SERVICE DIRECTIVE BULLETIN NO. 0113

1. SUBJECT: Cyclic Trim Actuator Switch Assembly Inspection
2. MODEL: F-28A, 280, F-28C, 280C, F-28F, 280F, and 280FX
3. EFFECTIVITY: S/N 828 and prior; S/N 2133 and prior
4. BACKGROUND:

Figure 1. Properly Installed Screws – The heads of the inner screws face the spring capsule.

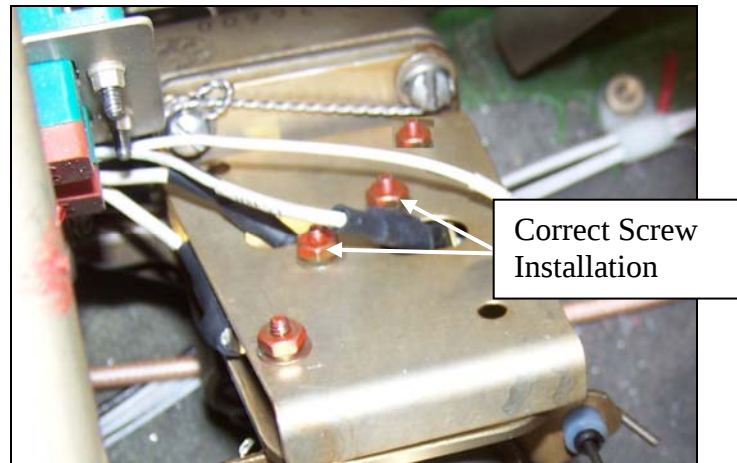
- 6.1 Locate the trim actuator assemblies by removing the seat deck.
- 6.2 Inspect the lateral and longitudinal trim switch assemblies for the proper screw orientation. The screw shanks and nuts should be visible on the wiring side of the switch assembly (*Figure 1 and Figure 2*). The heads of inner screws should be facing the spring capsule.

Figure 2. Improperly Installed Screws (a) (b) – The shanks of the inner screws face the spring capsule (b). (The trim actuator is removed from the aircraft.)

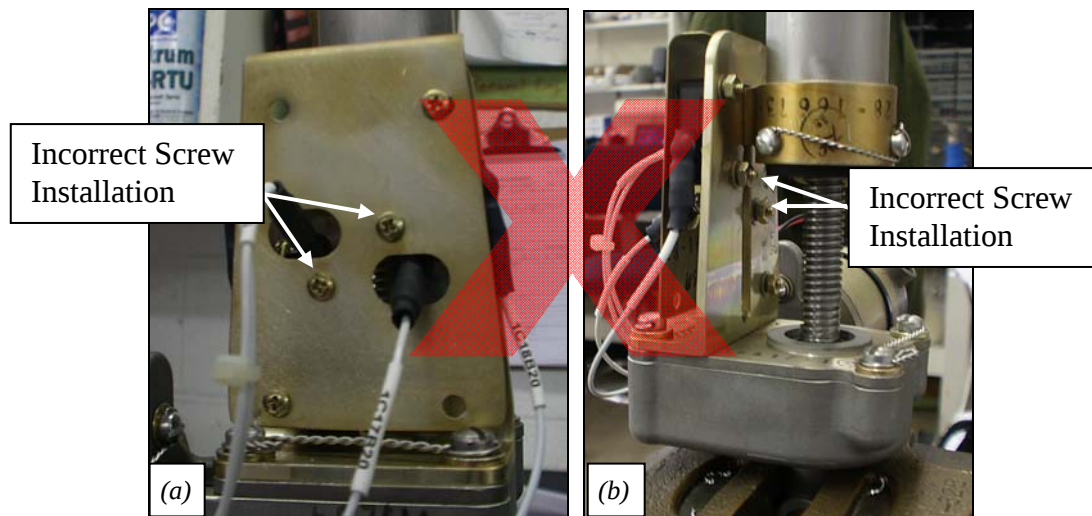
Enstrom has received a report of an incorrectly assembled trim actuator switch assembly used in the cyclic trim system. The screws that assemble the switches to the bracket were inadvertently installed in the opposite direction. This is a concern for the screws adjacent to the bracket slot, as the protruding shanks could interfere with the spring capsule travel and possibly compromise the performance of the cyclic trim system.

- 6.8 Remove the inner screws (3), washers (4) (5), and nuts (6) from the switch assembly. Re-install the inner screws (3), washers (4) (5), and nuts (6) such that the screw heads face the spring capsule. Use care to avoid moving the position of the switches when installing the screws.

Figure 3. Cyclic Trim Switch Assembly

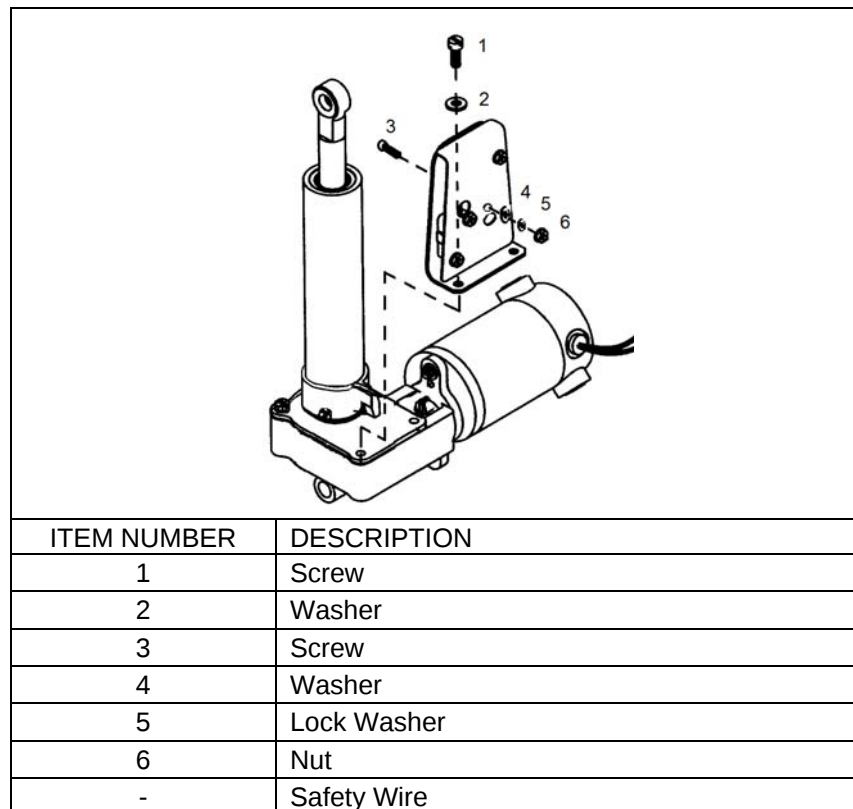
- 6.7 Remove the safety wire, screws (1) and washers (2) attaching the switch assembly to the trim actuator. Remove the switch assembly (*Figure 3*).

- 6.9 Re-install the switch assembly to the trim actuator assembly with the hardware removed in step 6.7 and safety wire.
- 6.10 Check the spring housing travel. Refer to SDB 0110 Rev. 3, or latest revision, for instructions on checking the travel and making required adjustments.
